Work Order ID 137893

Item Name: Quick Release Heli-Utility-Basket™ Long, HD Lid, Spacepod™/Squirrel Cheek Comp.

DART SERVICE INSTRUCTION

TO AMEND INSTALLATION INSTRUCTIONS D350-607-3 Rev.D,
INSTALLATION INSTRUCTIONS D350-607-4 Rev. C AND
INSTRUCTIONS FOR CONTINUED AIRWORTHINESS ICA-D350-607 REV. 6
REF TCCA STC: SH94-14
REF FAA STC: SR00213NY
REF EASA STC: EASA.10016996
REF BRAZILIAN STC: 2007S03-03/-04/-05/-06

FIGURE 1: INSTALLATION OF D4775-041 FWD STRUT

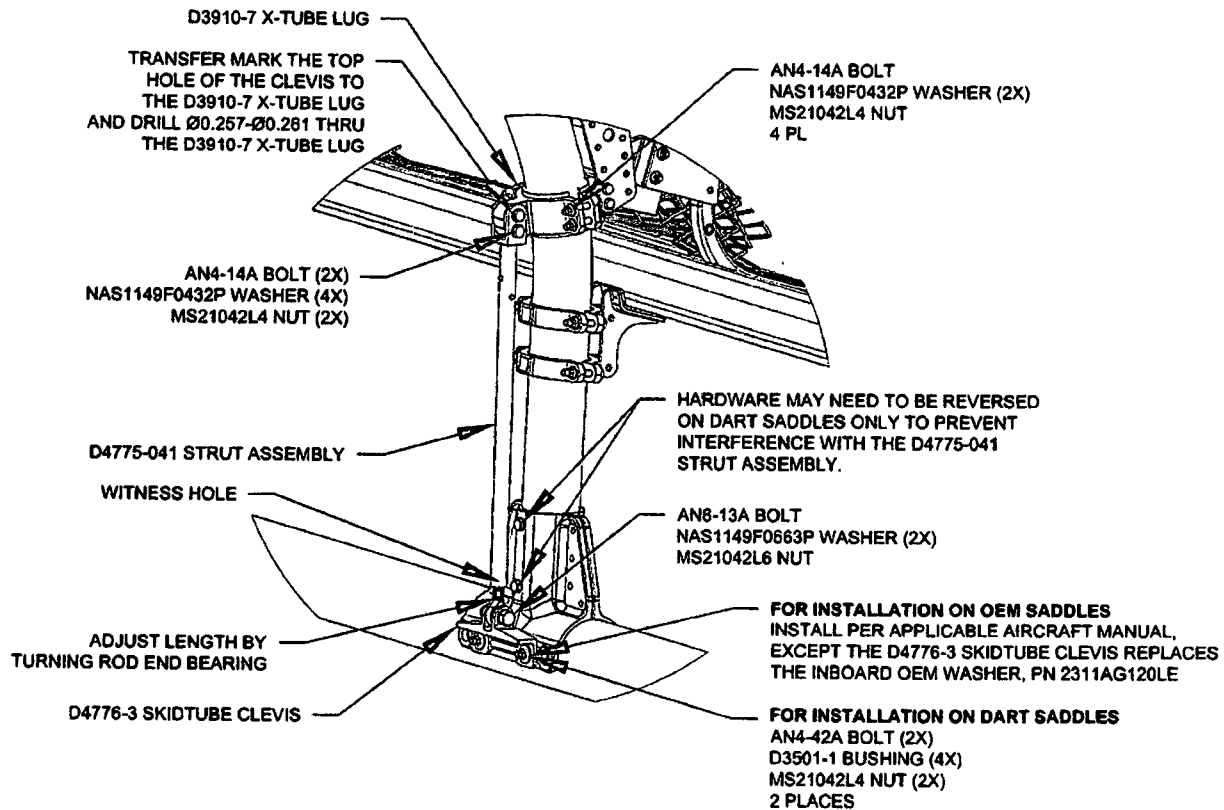
- 3.1 Substitute the Forward Lower D3910-5 X-Tube Lug with the D3910-7 X-Tube Lug as shown in Figure 1.
- 3.2 Install the forward D4775-041 Strut Assembly. Transfer mark from the upper hole on the clevis of the D4775-041 Strut Assembly to the D3910-7 X-tube Lug and drill thru the lug $\varnothing 0.257 - \varnothing 0.261$ as shown in Figure 1. Touch up chemical conversion coating per MIL-DTL-5541. Check the witness holes located at the bottom end of the D4775-041 Strut Assemblies to ensure that the thread from the rod end extends past the witness hole.
Torque MS21042L4/-4 nuts to 50-70 in-lbs (5.7-7.9 N-m). Torque MS21042L6/-6 nuts to 160-190 in-lbs (18.1-21.5 N-m).
- 3.3 Complete the installation in accordance with Installation Instructions D350-607-3 Rev. D or D350-607-4 Rev. C.
